50-329/330 OM, OL

Exhibits from
10/9/80 Deposition
of
Lyman Hallett

DISCUSSION OF THE APPLICANT'S POSITION
ON THE NEED FOR ADDITIONAL ECPINGS
FOR
MIDLAND PLANT UNITS 1 AND 2
CONSUMERS POWER COMPANY
DOCKET NUMBERS 50-129 AND 50-130

SUBJECT: Interagency Agreement No. NRC-03-79-167, Task No. 1 - Midland Plant
Units 1 and 2, Subtask No. 1 - Letter Report

Figure 37-1

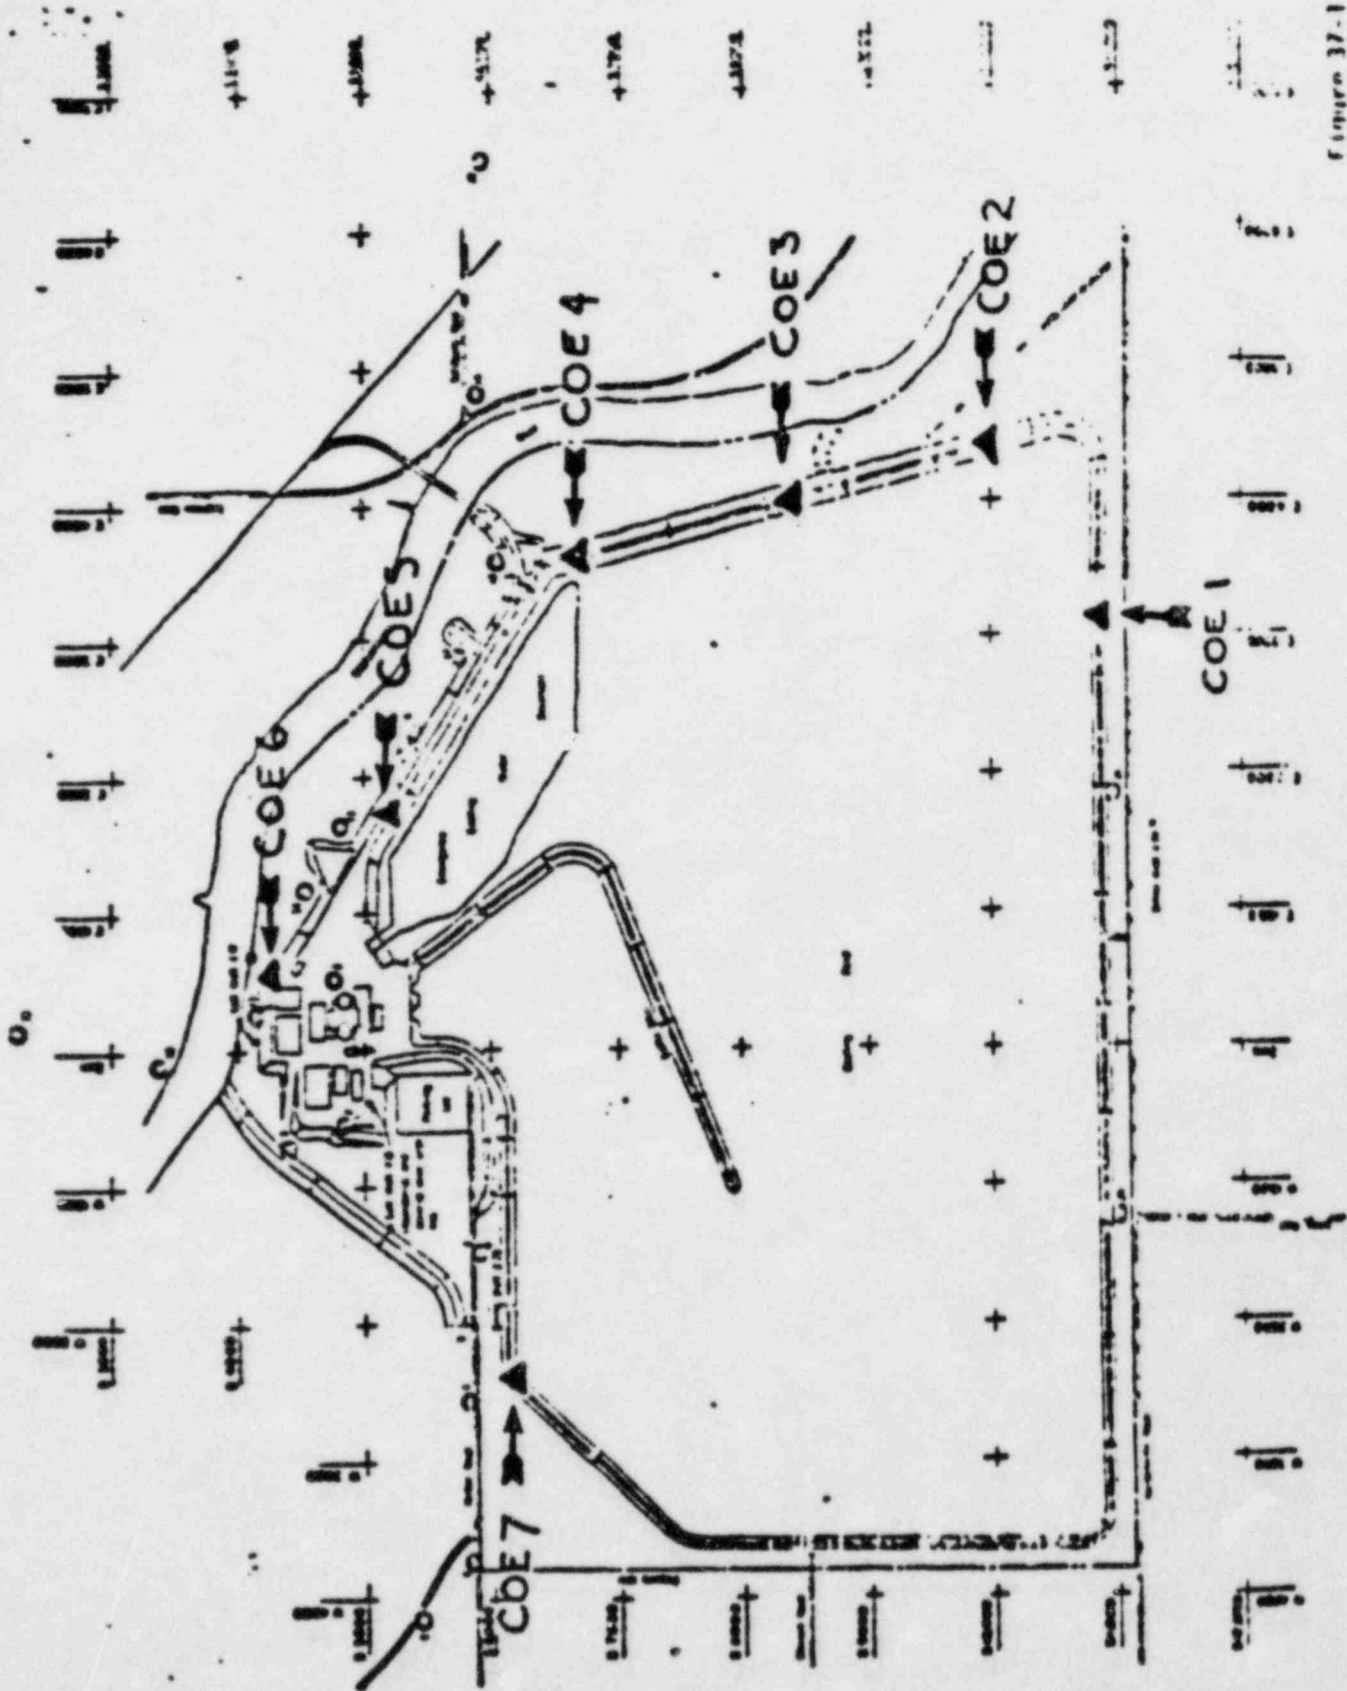
37. (RSP) Your position in previous responses to Requests 5 and 35 not to complete additional explorations, sampling and laboratory testing following the preload program continues to be unacceptable. We require that you complete as a minimum, the exploration and testing program indicated by Table 37-1.
38. Discuss the foundation design for any seismic safety-related piping and conduit connected to or located under the Radwaste Building and Turbine Building where piping and conduit have been placed on plant fill.
